Delegated Report

Householder Planning Application

Planning Application No: 20221341
20221344

Location: Ashley Down Nursing Home 29 Clarence Place Gravesend Kent

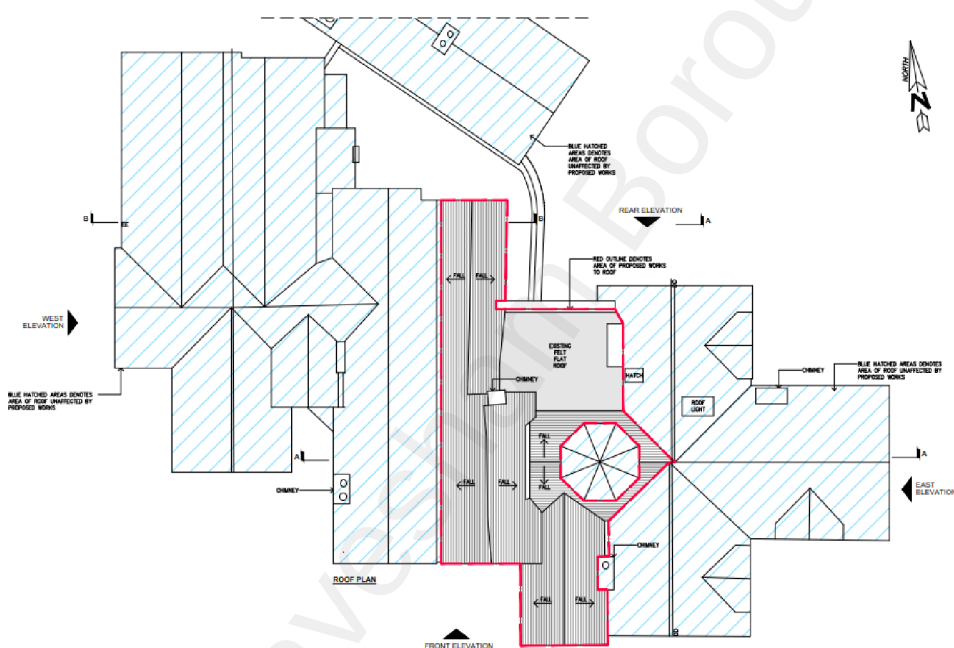
The works relate to a central part of the roof of the building as shown in red below and which is said to be in a poor state of repair as evidenced in the photographs in the planning statement.
